IFB # 2020-008
Walking Trail of Lights at Roanoke County's Explore Park

ADDENDUM NO. 3

Clarifications and Updated Project Drawings

EXPLORE PARK – RIVERSIDE WALKING LOOP
EXPLORE PARK COUNTY OF ROANOKE, VIRGINIA

ONE LINE DIAGRAM

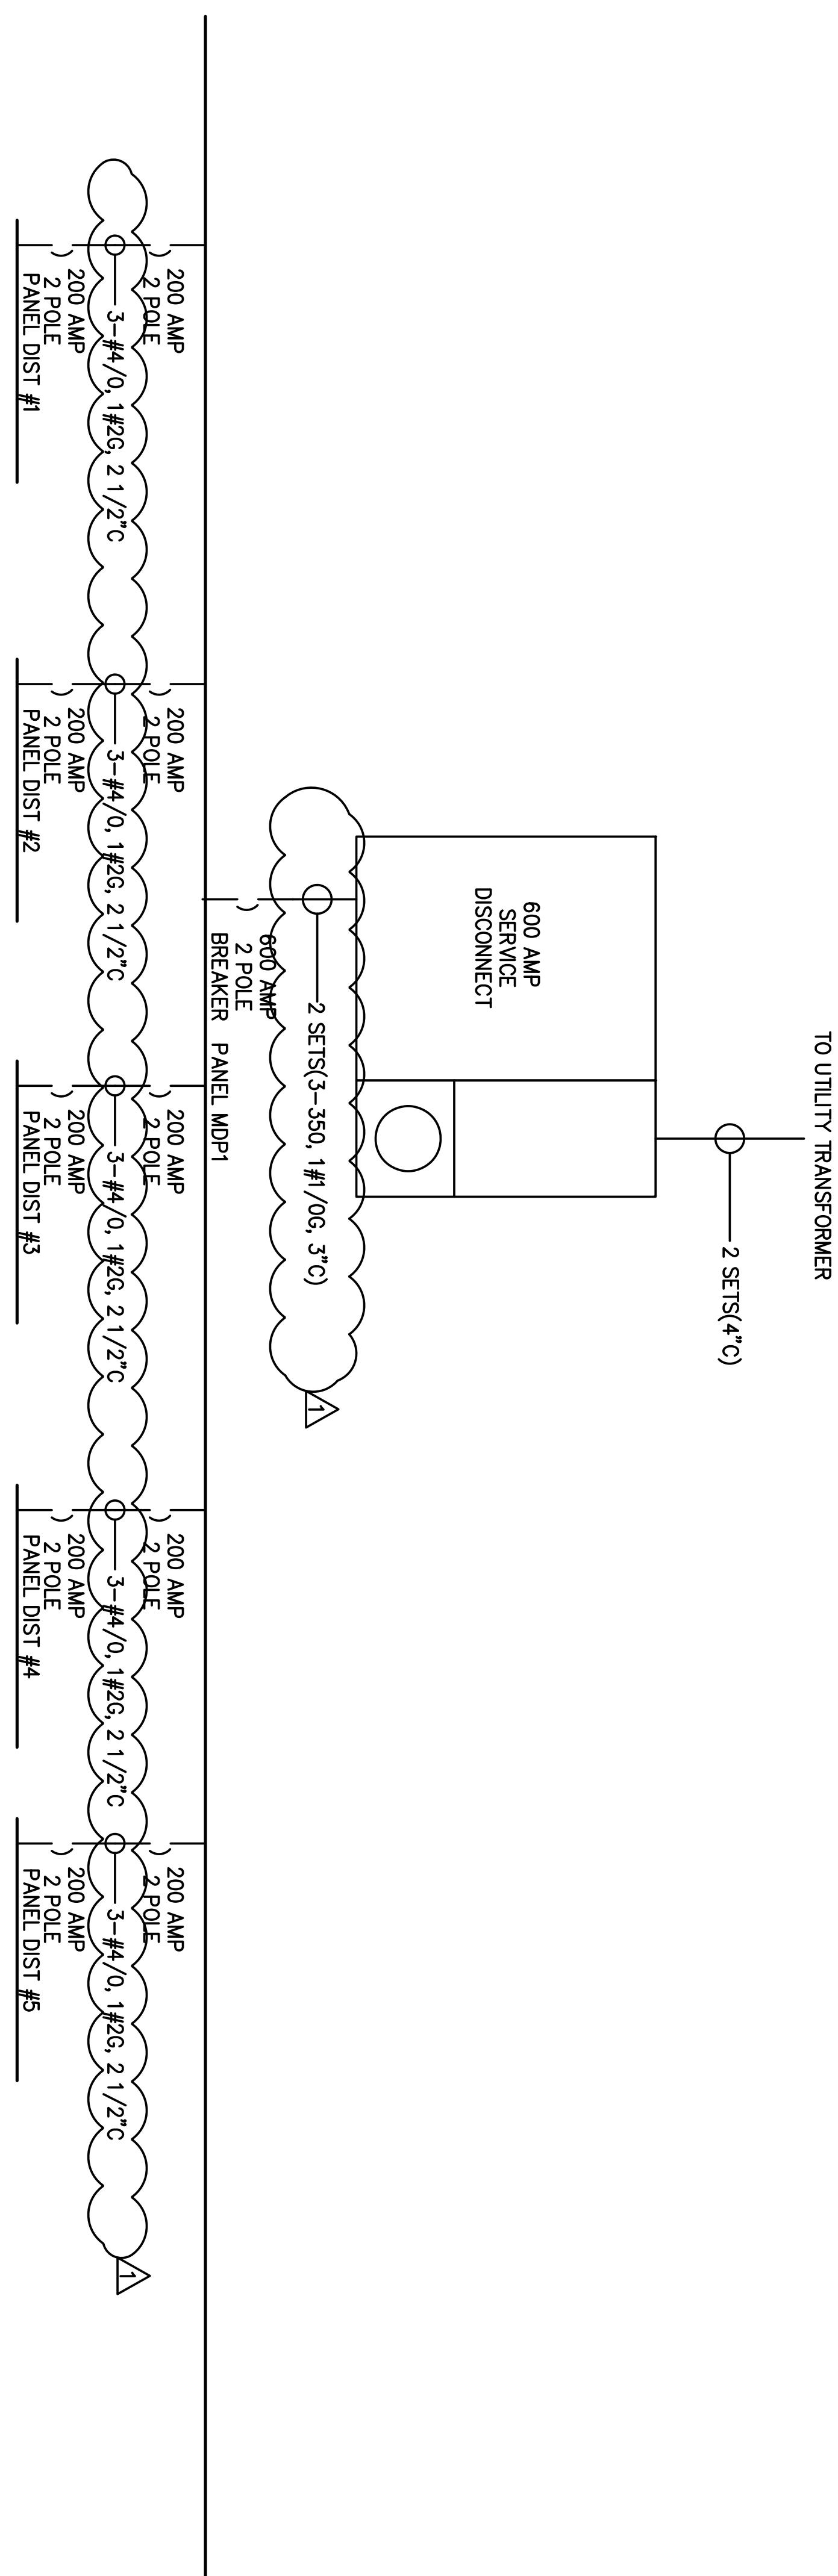
- c. How can we terminate 4/0 wire onto a 60 amp breaker? Lugs are not large enough on the breaker for 4/0 wire.

Bidders should supply 200AMP breakers in place of the 60AMP breakers specified in the “PANEL MDP” schedule on page E1.2 of the plans. The 200 AMP breakers will need to accommodate the size #4/0 wire that was specified in a previous addendum to fee the Distribution Panels.

EXPLORE PARK - RIVERSIDE WALKING LOOP
EXPLORE PARK COUNTY OF ROANOKE, VIRGINIA
ELECTRICAL SITE PLAN

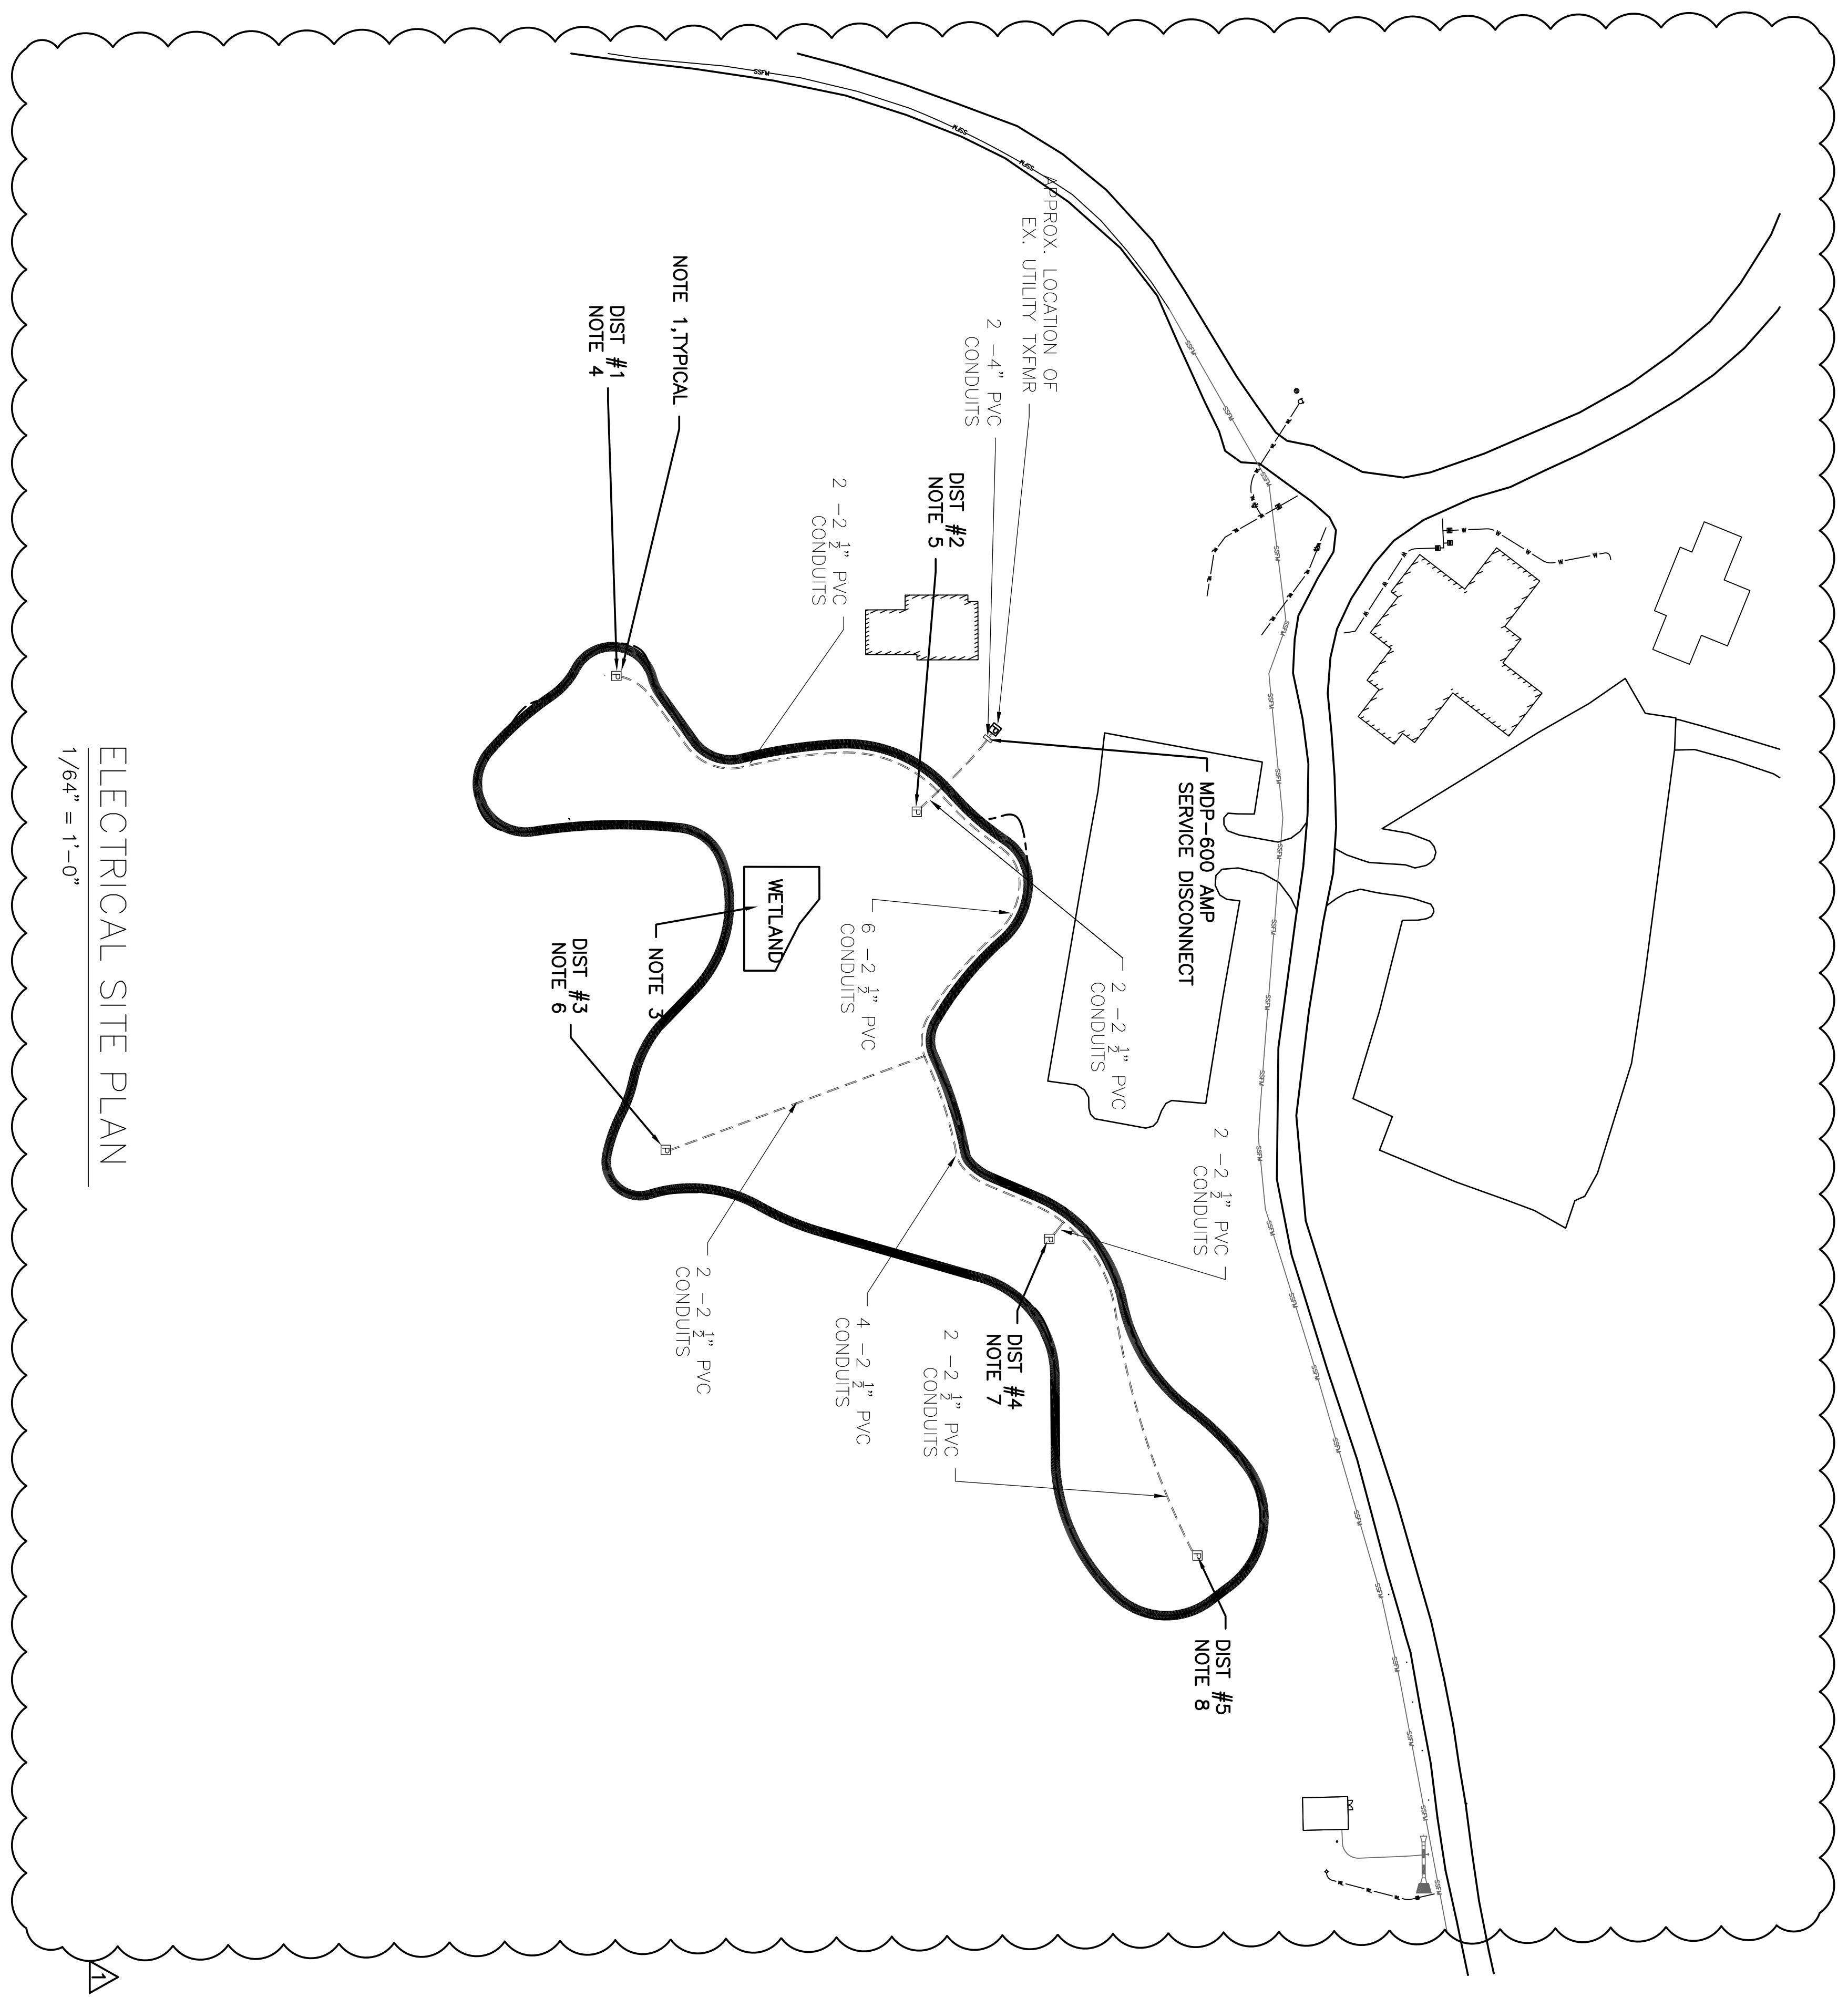
- a. Coming off the sub panels to the 20 amp GFI outlets, no conduit detail is shown except on the main trunk feed to sub panels. What size conduit is needed to those GFI locations?

- b. On the power runs to GFI outlets, should the route taken follow the existing 2" conduit, then dip off the trail, or go straight through the woods?

GFI receipts are located on the power pedestals. There should be none run along the trail.

GFI receipts are located on the power pedestals. There should be none run along the trail.

In regards to GFCI locations and conduits, please refer to the “NOTES THIS SHEET” and “GENERAL NOTES” sections on Sheet E1.1 of the plans.

Conduit size to the receptacles will be ¾" from sub-panel to receptacle, but as stated in the notes of the plans, all GFCI receptacles will be “mounted beside panel” at each distribution panel location. There will be no ¾" conduits and GFCI receptacles located throughout the woods. The curved lines shown on Sheet E1.1 of the plans from each distribution panel are meant to represent how drop cords would be used by the owner for light displays. Those curved lines do not represent any work to be provided by the contractor.
